Before the  
UNITED STATES NUCLEAR REGULATORY COMMISSION

Allens Creek Nuclear Generating Station Unit 1

Amendment 50 to the  
PSAR

HOUSTON LIGHTING & POWER COMPANY  
ALLENS CREEK NUCLEAR GENERATING STATION - UNIT NO. 1  
PRELIMINARY SAFETY ANALYSIS REPORT  
AMENDMENT NO. 50  
INSTRUCTION SHEET

SPECTRA COMPARISON  
FLUSH-A VS SPRING-A  
FIGURE 3.7.A-21

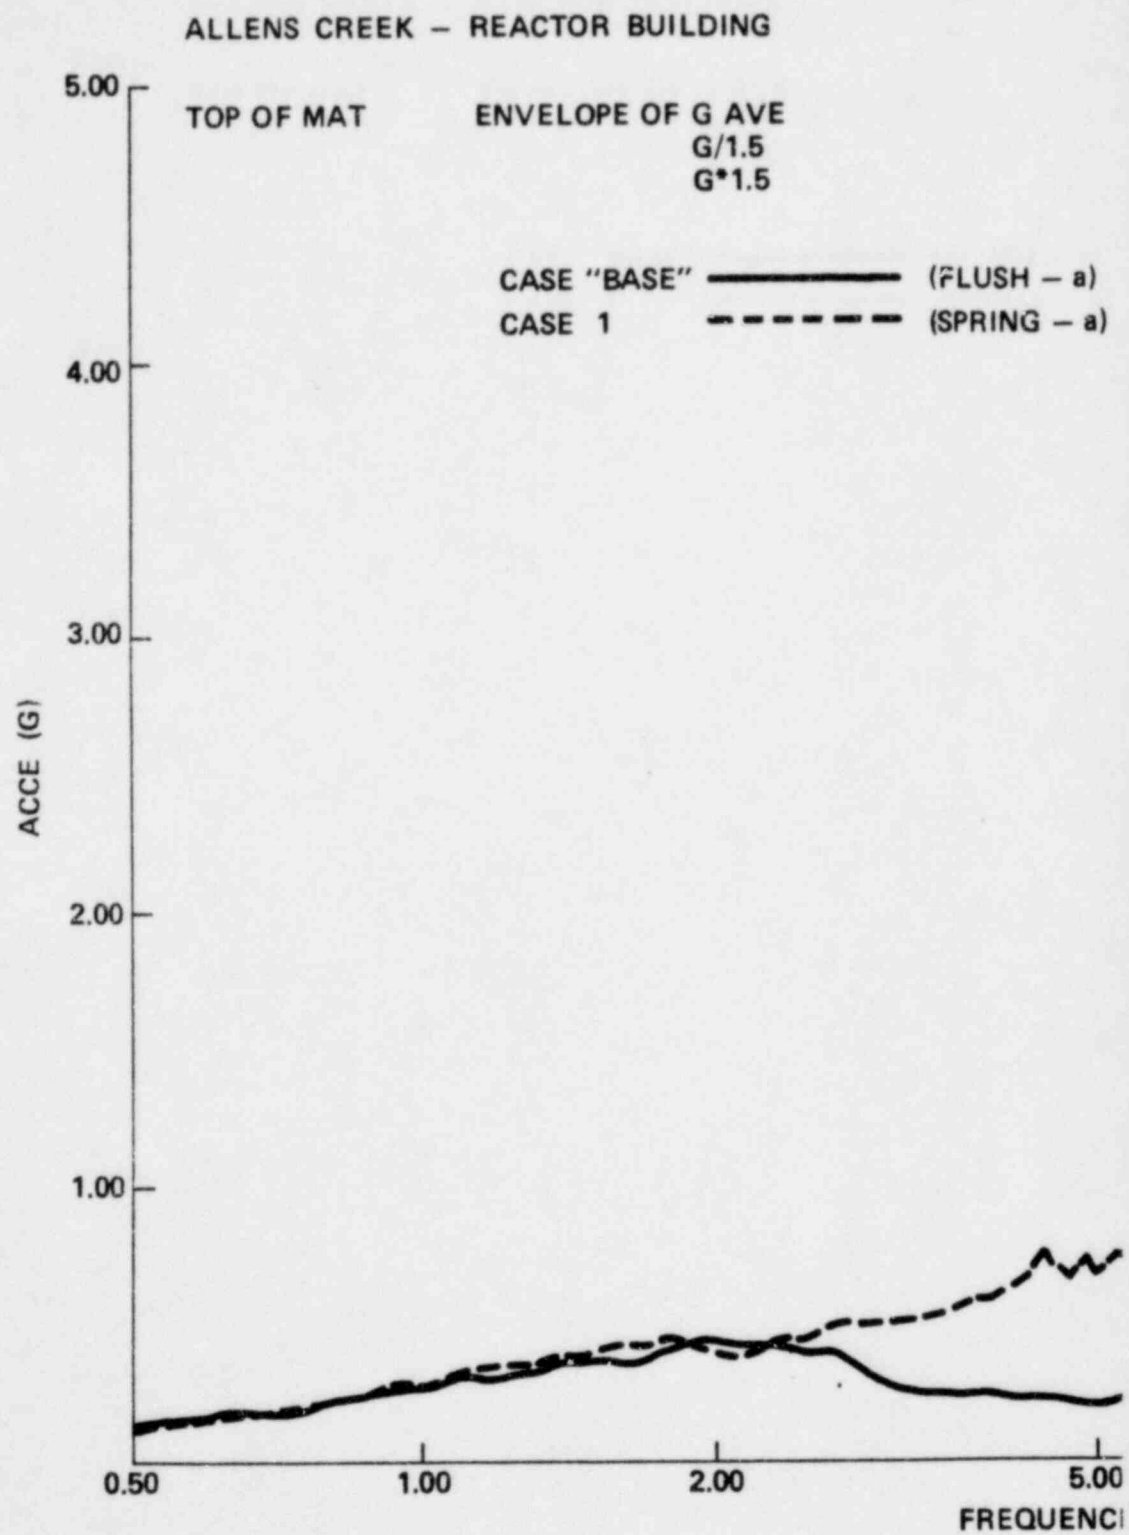
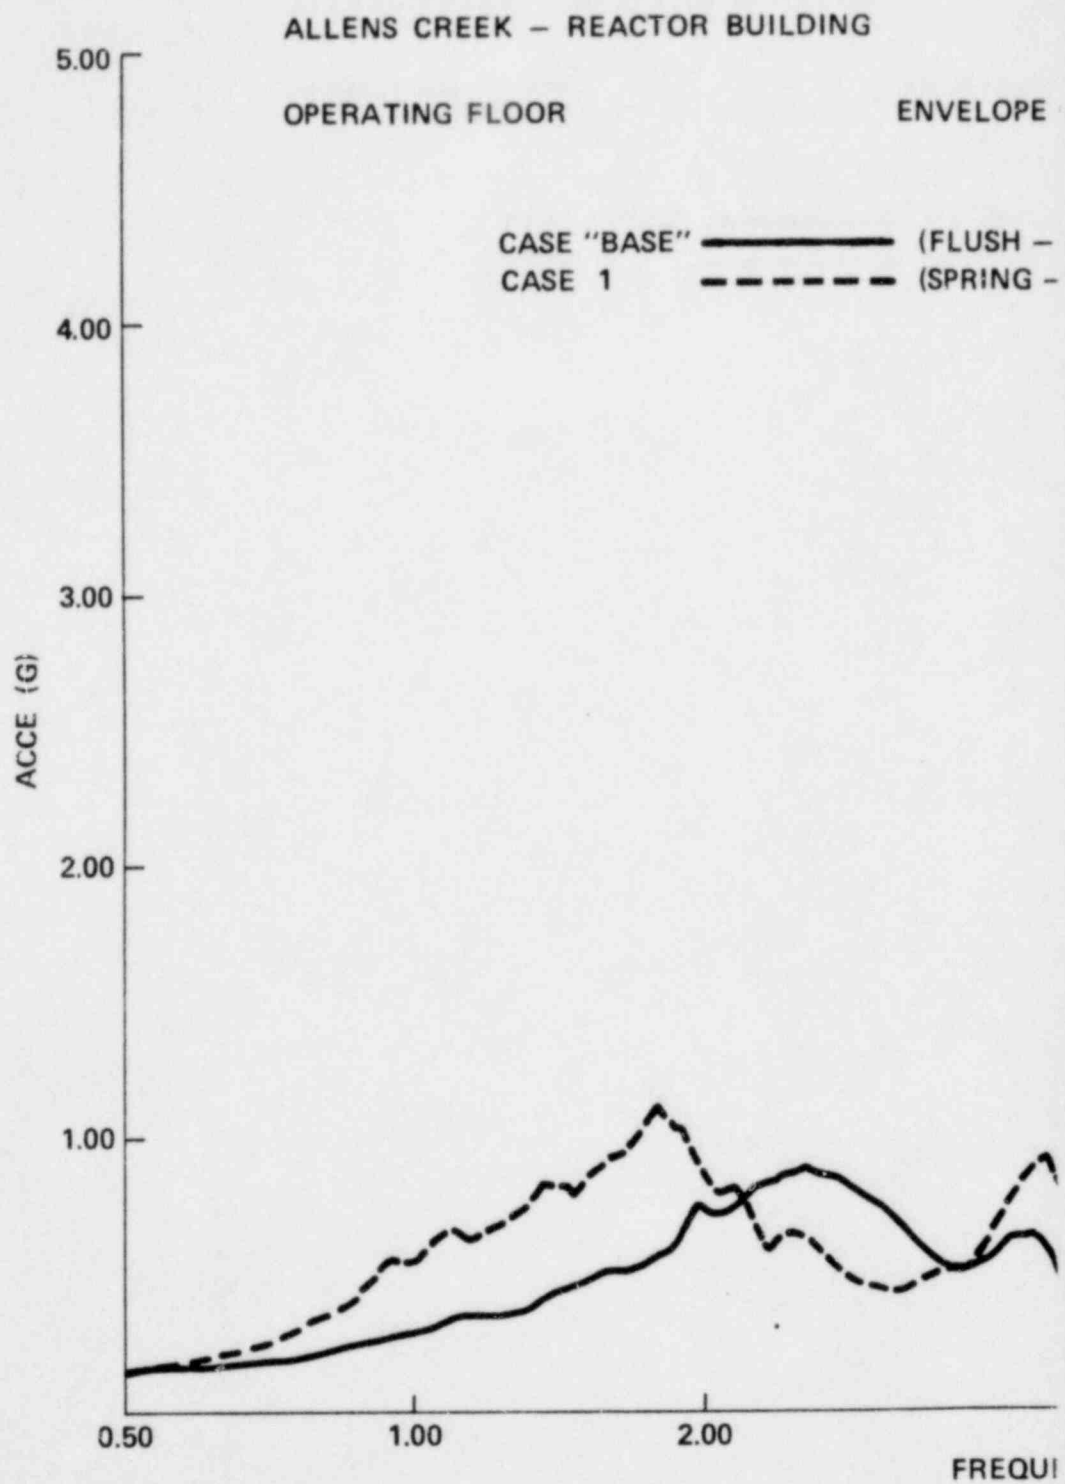
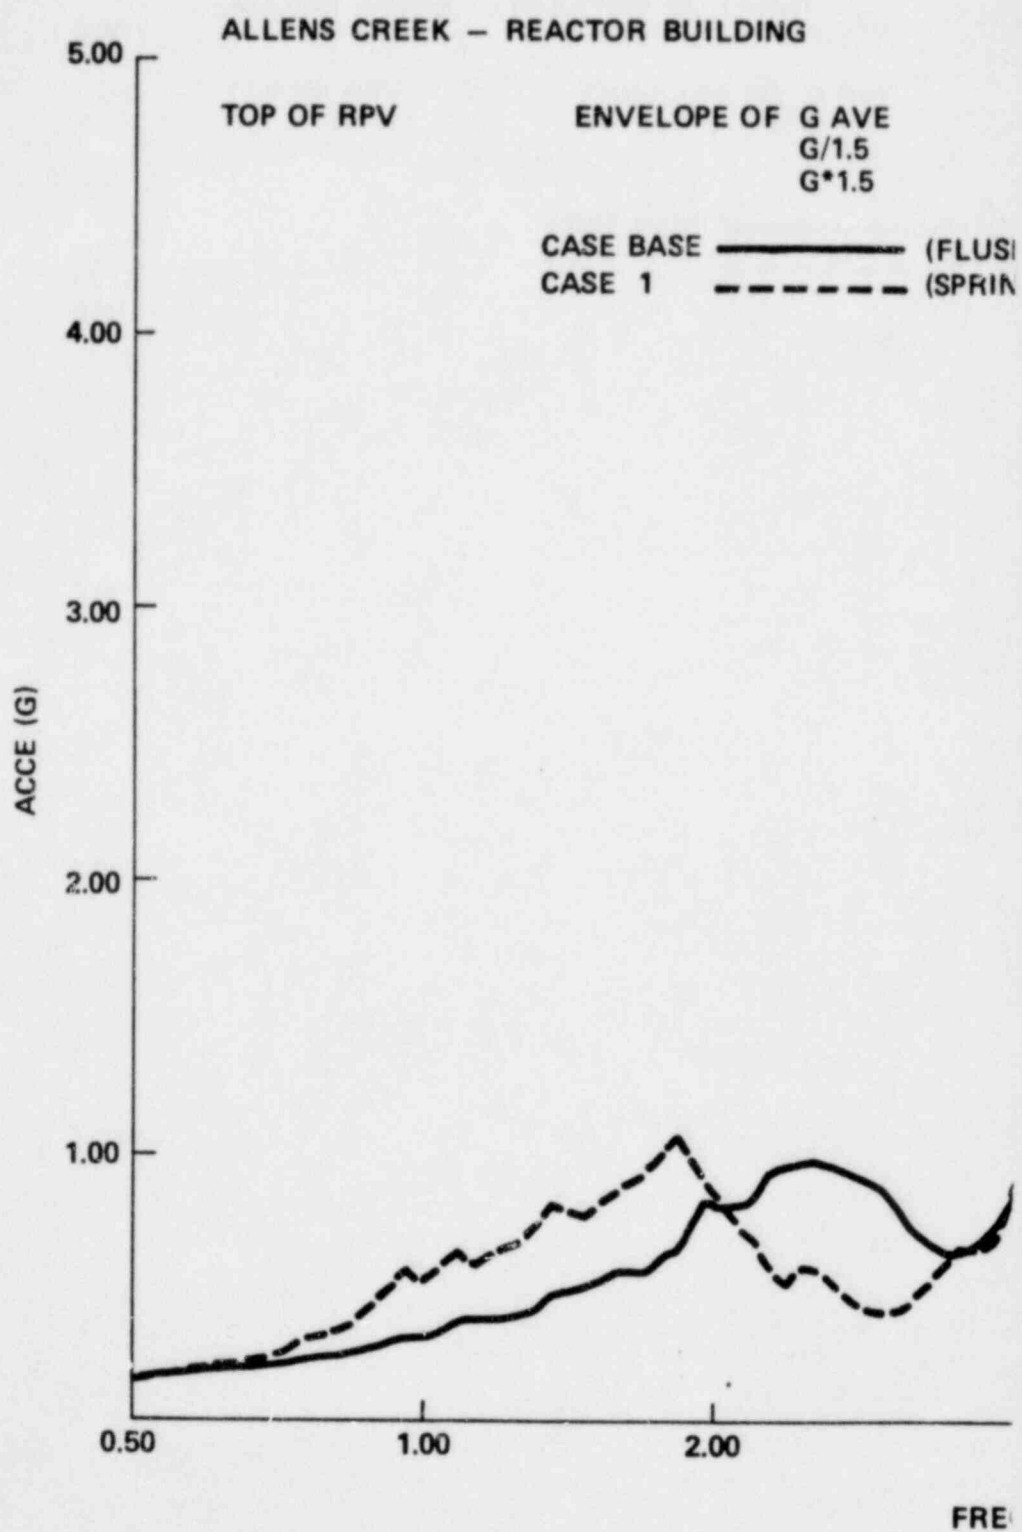
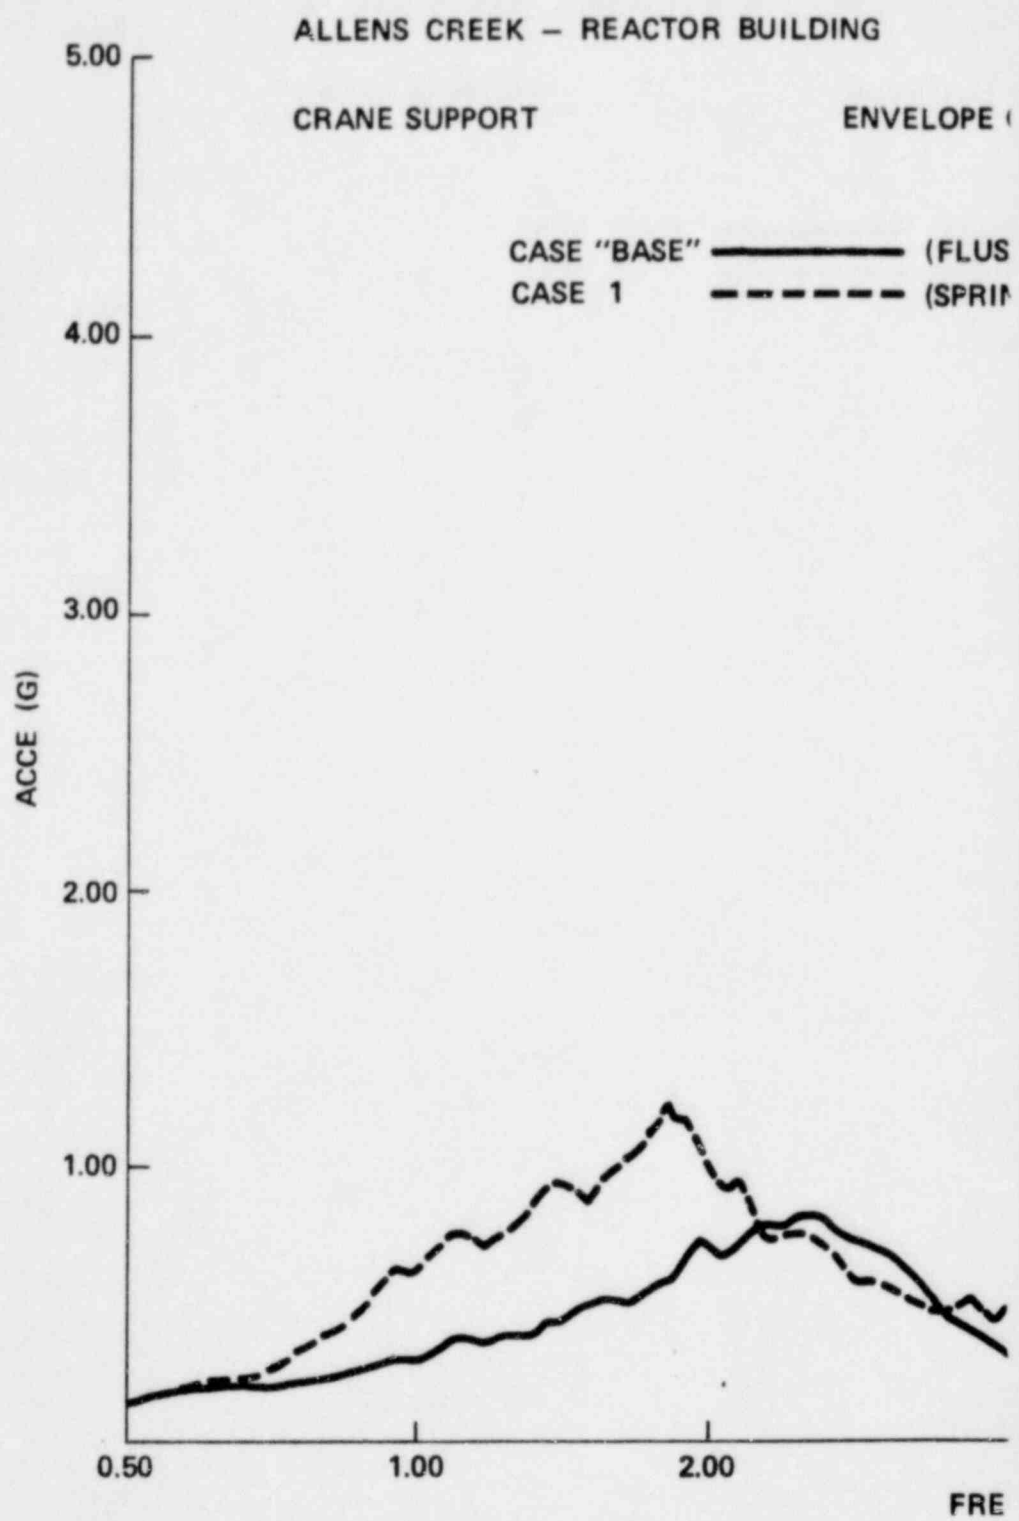
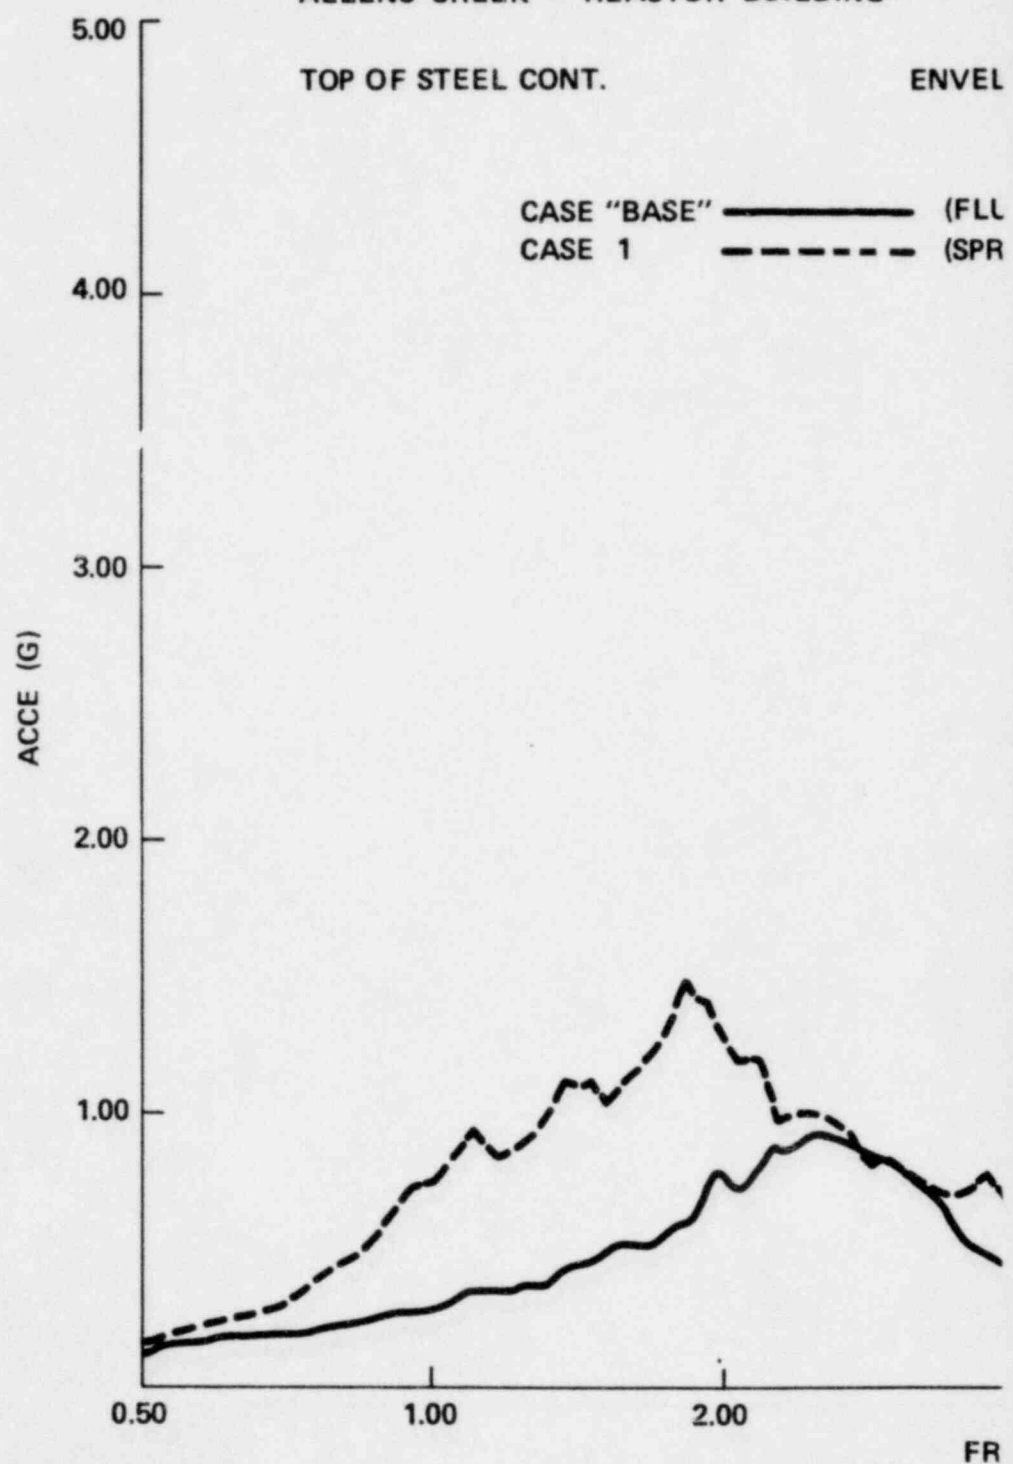
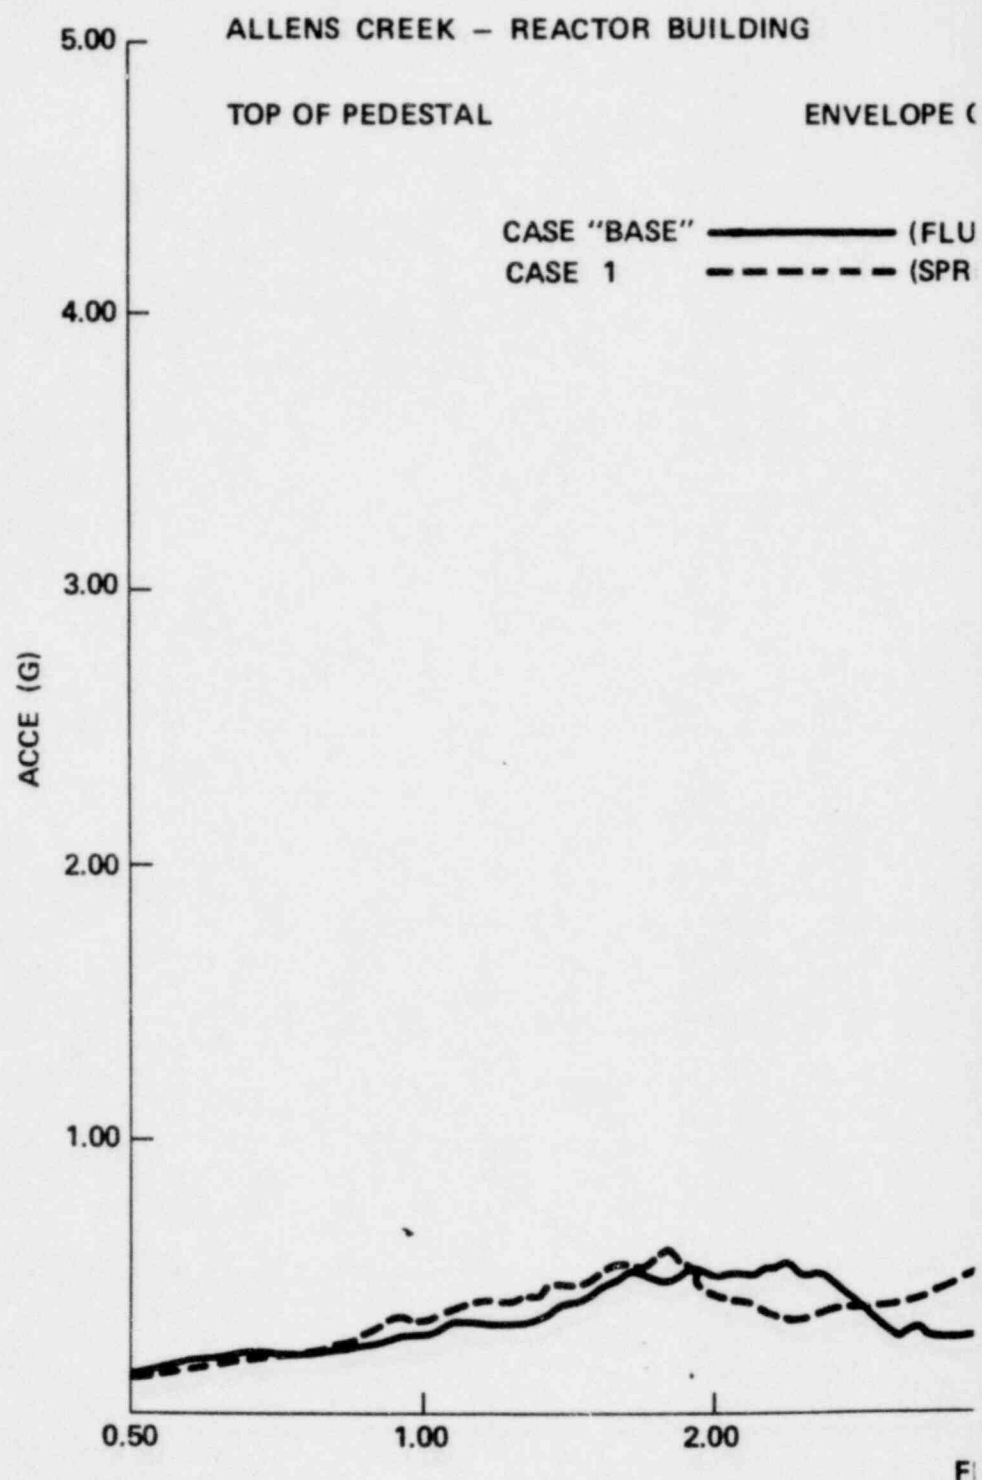
During discussions with the NRC, analyses were performed comparing the effect of the location of the control motion with respect to the Reactor Building. A comparison of accelerations obtained at various points (refer to Figure 3.7A-2) indicates a relatively close agreement between results obtained with the control motion defined at the bottom of the Reactor Building mat (FLUSH-b) vs. at the ground surface (FLUSH-a). Maximum accelerations at various points from the above two cases are presented in Table 3.7.A-3 and
